CONSERVATION TEAM CONSULTATION APPLICATION RESPONSE

APPLICATION REF:	26/00318/FP
CASE OFFICER:	TH
APPLICATION SITE:	Barn to the west of Lordship Farmhouse, Pirton Road Holwell, Hertfordshire
DESCRIPTION OF WORKS:	Conversion of a grade II listed building and associated curtilage listed building to two semi-detached residential dwellings (1 x 3-bed and 1 x 4-bed) including demolition of modern extension and replacement single storey extension. Erection of four detached and semi-detached dwellings (4 x 4 bed); four bay cart shed for covered parking; associated parking and gardens; and minor alteration to existing vehicular access and partial widening of access road following demolition of existing structures.

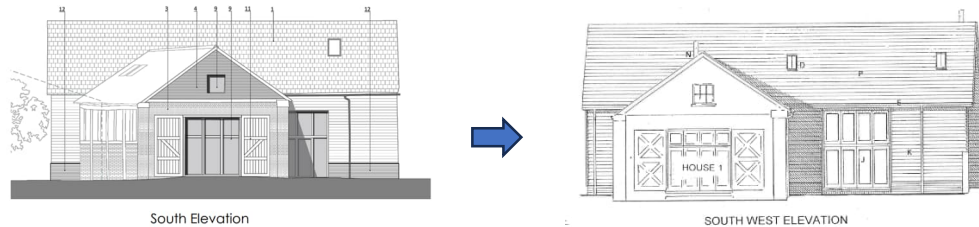
I am unconvinced by the northwest elevation gable end fenestration and question the justification for the 4no. first-floor windows that serve a mezzanine sitting area. Could this not be reduced to two? Furthermore, the repetition of 8no. openings to the right of this gable creates an overtly domestic character. Considering the lack of framing in this part of the barn, I would not be opposed to let's say a 'picture window' or two being introduced (see below) and which would also maximise views out towards Holwell church. These could be different sizes (blue infill below) and omit glazing in red infill. I appreciate that such openings would not be the same 'language' as the more conventional openings.

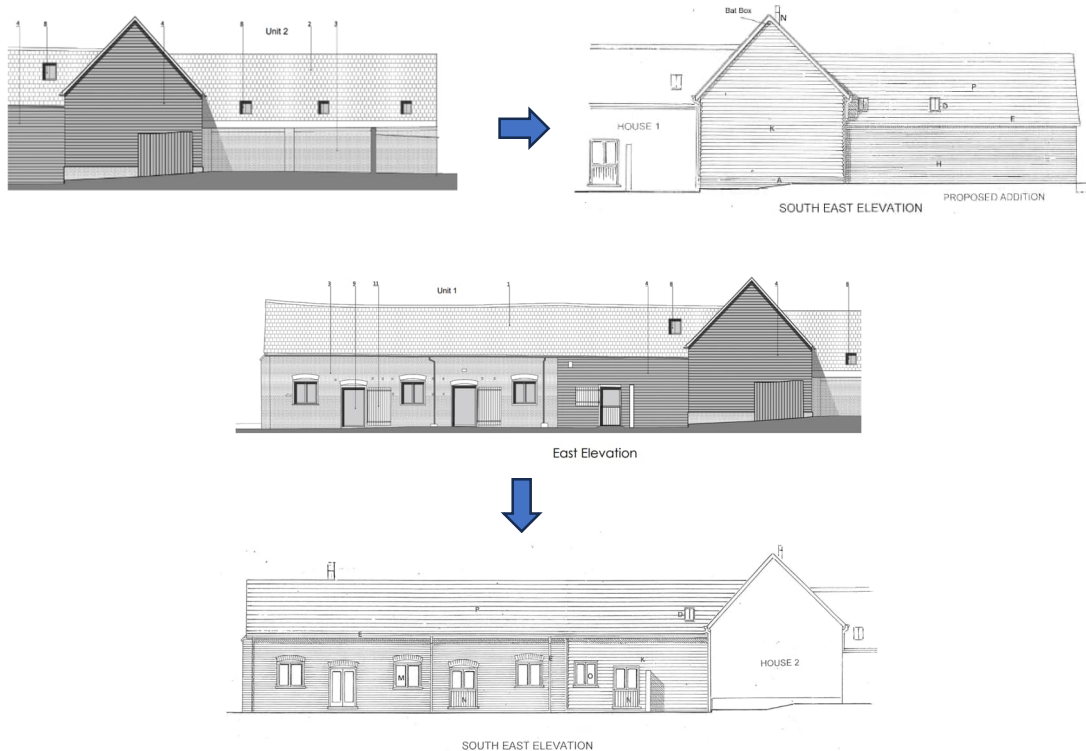
I am satisfied that the Southwest Elevation will work well. Lugged-and-braced as opposed to cross-braced doors may be slightly better for the large 'shutter' doors but that is a minor point (see doors below on main barn). Regarding the floor plan for House 1, the 'shutter' doors to the gable end are not shown and I also queried on site the ceiling height of the rooms in this unit.
